**Florida
Power**
CORPORATION

September 13, 1989
3F0989-01

Subject: Crystal River Unit 3
Docket No 50-302
Operating License No. DPR-72
Revision to FSAR Radiological Consequences

FIGURE 14-65

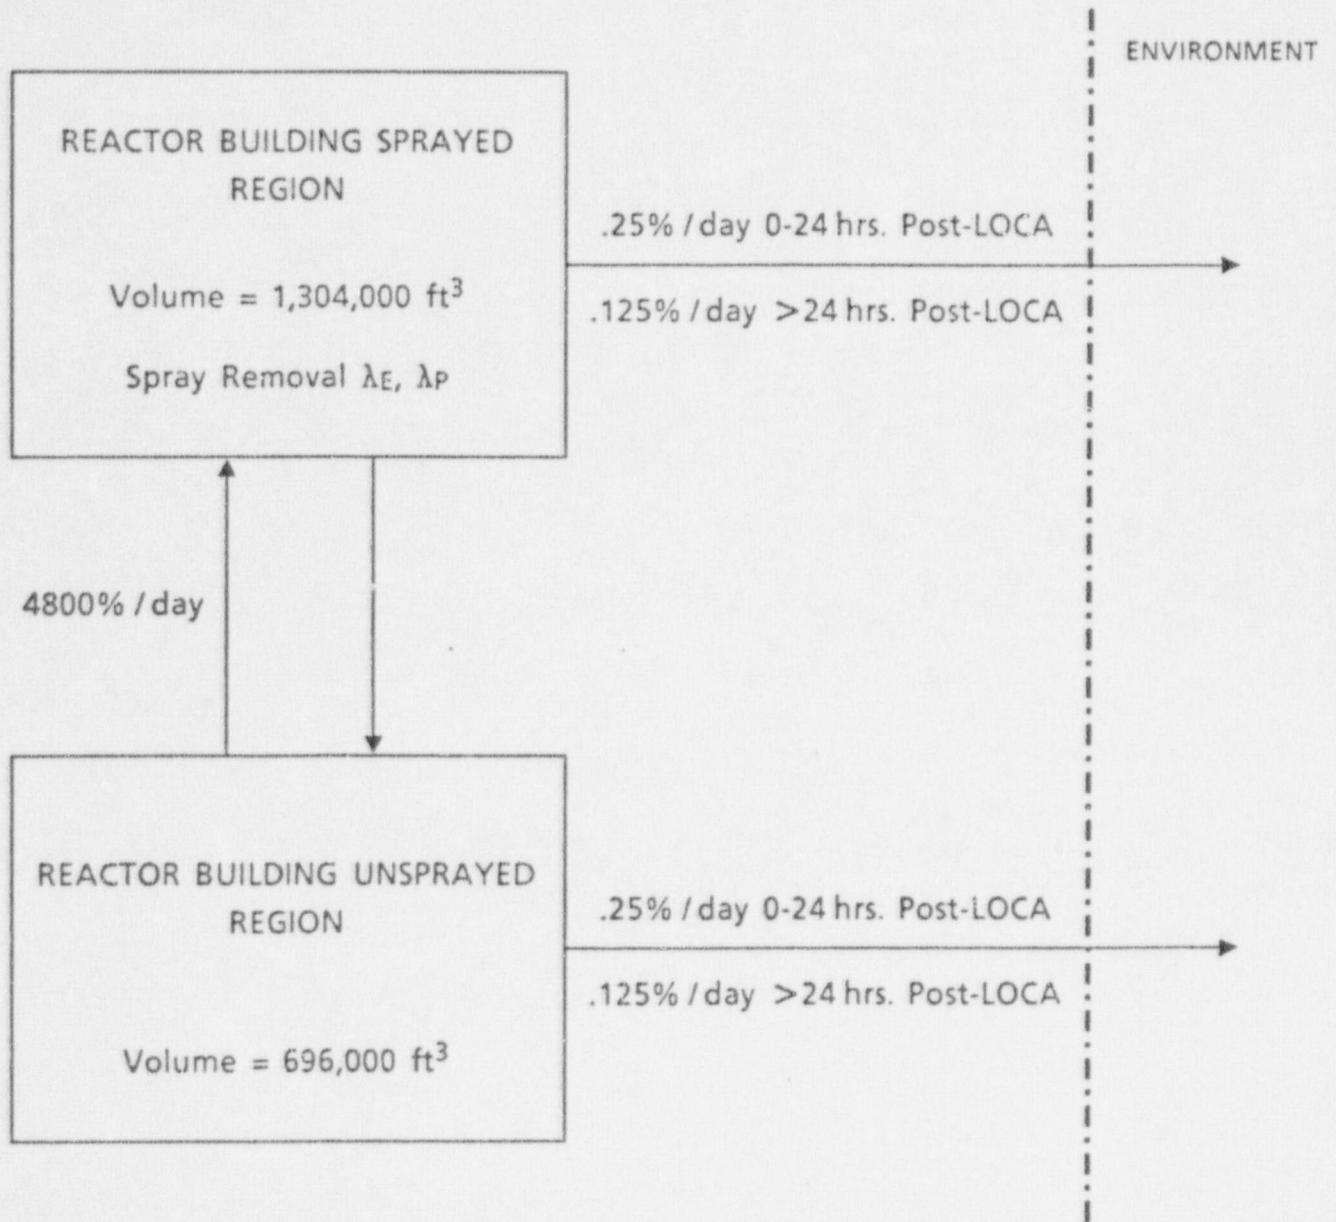
The activity flow path models utilized in the analyses for Reactor Building Leakage, Recirculation Loop Leakage, and Control Complex Inleakage is given in Figures 14-65, 14-66 and 14-67, respectively. Both the Design Basis and Realistic Basis analyses are based upon the assumption that the RB Spray System is functioning in a degraded (worst case) mode of operation, i.e. spray pump failure.

FIGURE 14-67

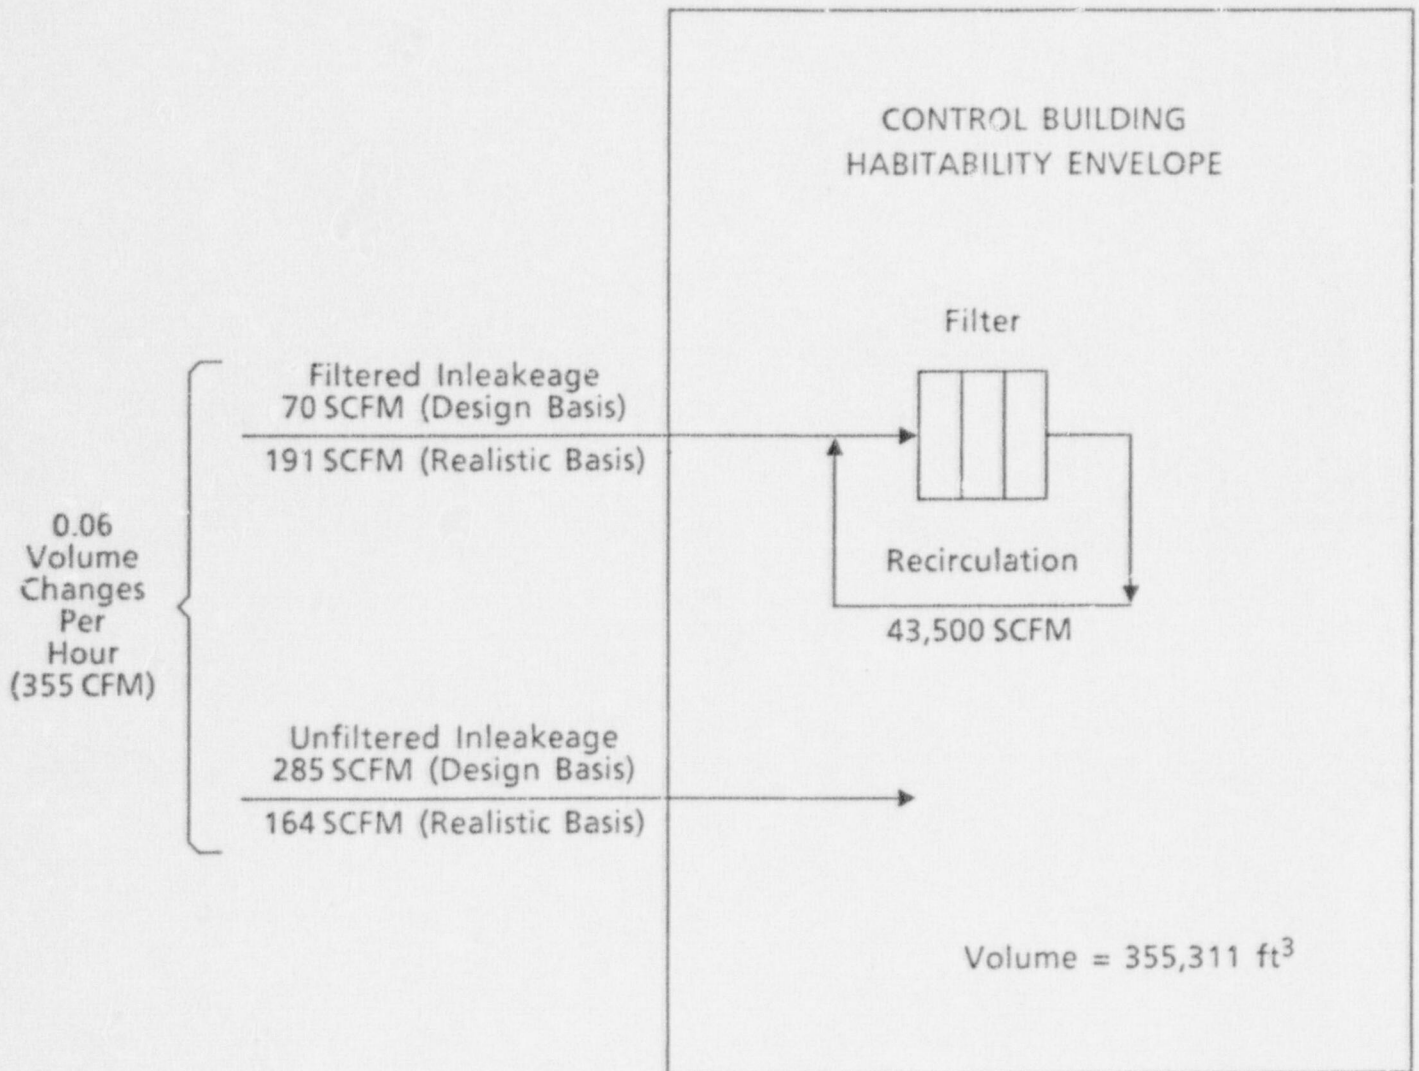
Ventilation System Mode Of Operation: Zone Isolation With Filtered Recirculating Air.
